Technical Bulletin

Date: October, 2002
No: TDL-0001B-B
TCL-0001-B
Page 1 of 1

Type	Policy Letter √ Service Information
Attention	Service Managers √ Service and Parts Managers
Models	Performa "L" / Dependable Care, Atlantis
Issue	New non-adjustable lid switch.
Warranty	See specific product warranty for details.
Action	When replacing lid switch, or to eliminate lid switch adjustability issues. Order "Lid Switch Kit" 12001908. Kit contains new plunger (For Atlantis Only), switch, and instruction sheet.

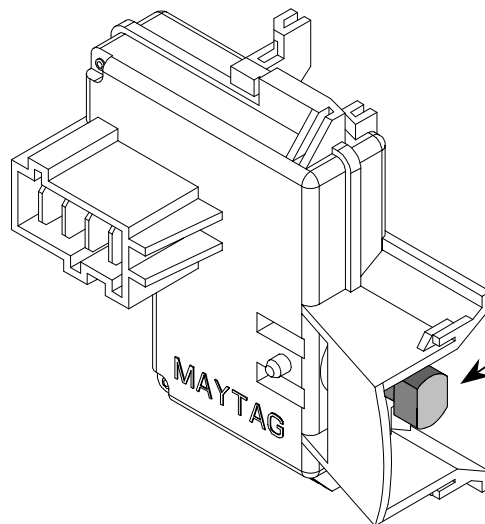
Identify switch by "gray" actuator button.
